# UNITED STATES PATENT AND TRADEMARK OFFICE

APPLICATION NO.	FILING DATE	FIRST NAMED INVENTOR	ATTORNEY DOCKET NO.	CONFIRMATION NO.
10/601,185	06/20/2003	Shinichi Kurita	007390 DISPLAY/AKT	6777

## Office Action Summary

## DETAILED ACTION

Bourel et al. :

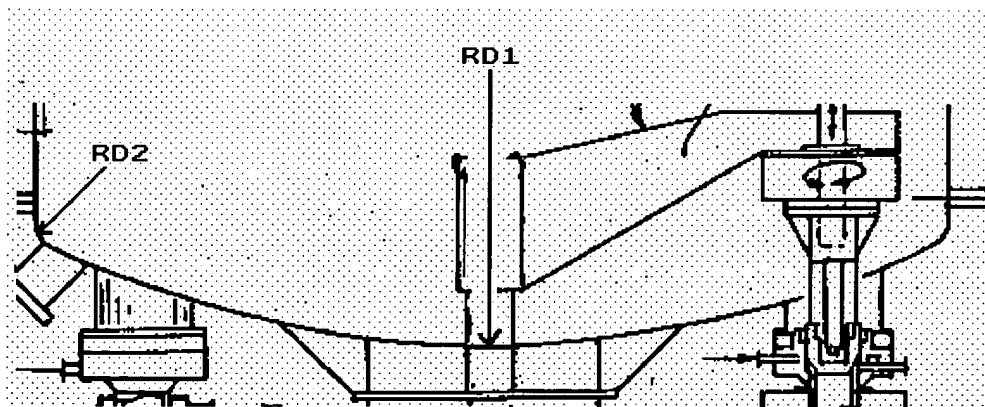
In response to the argument that the prior art does not suggest a domed region having a first radiused portion having a first radius of curvature; and a second radiused portion extending between the first radiused portion and the cylindrical region and having a second radius of curvature that is less than the first radius of curvature, it is argued that Bourel et al. do teach the required radius of curvature as shown in the Figure below and compared to Applicant's claims and Applicant's Figure 4.
